ATTENTION—PRODUCT CHANGE

As you open this packaging, you will notice the new HS35R encoder is inside. The new HS35R differs dimensionally from the existing HS35. Refer to the back of this flyer for key dimensional differences.

Encoder Critical Dimensional Differences:

HS35R Dimensions

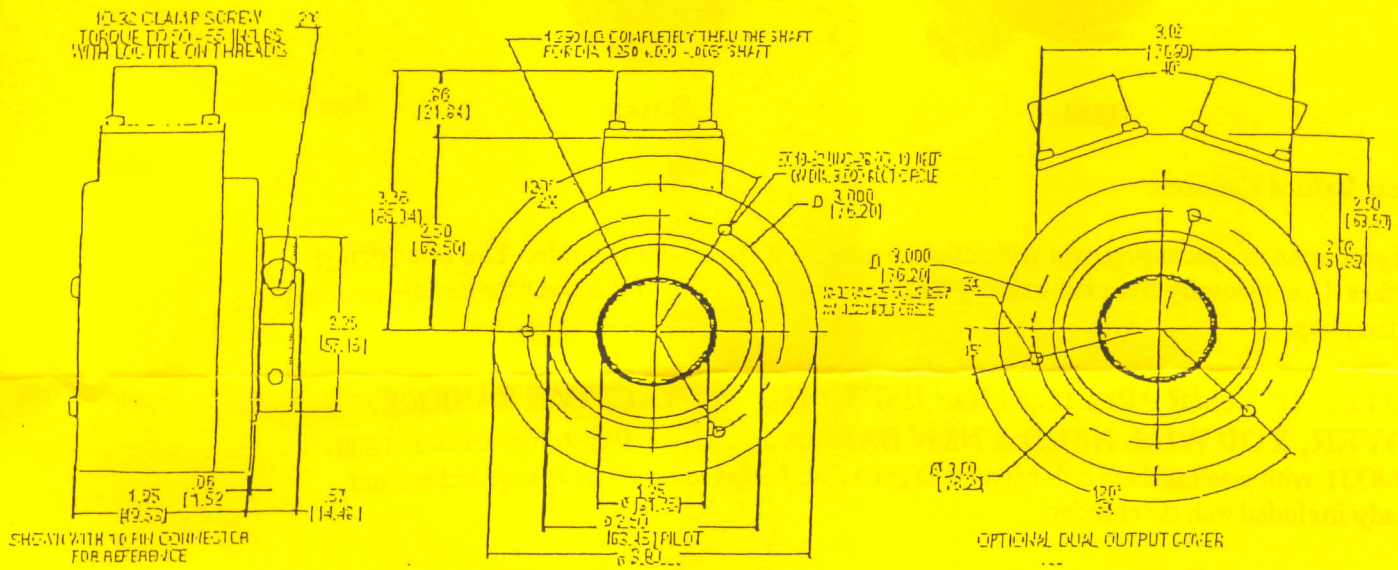
NOTE: IF YOUR APPLICATION USES THE PROTECTIVE BASKET COVER, YOU WILL NEED A NEW BASKET. Please call customer service at 800-873-8731 with your purchase order number to get a free basket cover if one is required and not already included with the encoder.

DIMENSION	HS35	HS35R	Difference
Diameter	3.54"/89.9mm	3.80"/96.52mm	.26"/6.62mm
Clamp Diameter	1.93"/49.0mm	2.25"/57.15mm	.32"/8.15mm
Housing Depth (Thickness)	1.45"/36.8mm	1.95"/49.53mm	.50"/12.73mm
Total Depth (to Clamp Edge)	1.80"/45.7mm	2.52"/64.01mm	.72"/18.31mm
Centerline to Connector Base	2.25"/57.2mm	2.50"/63.50mm	.25"/6.30mm
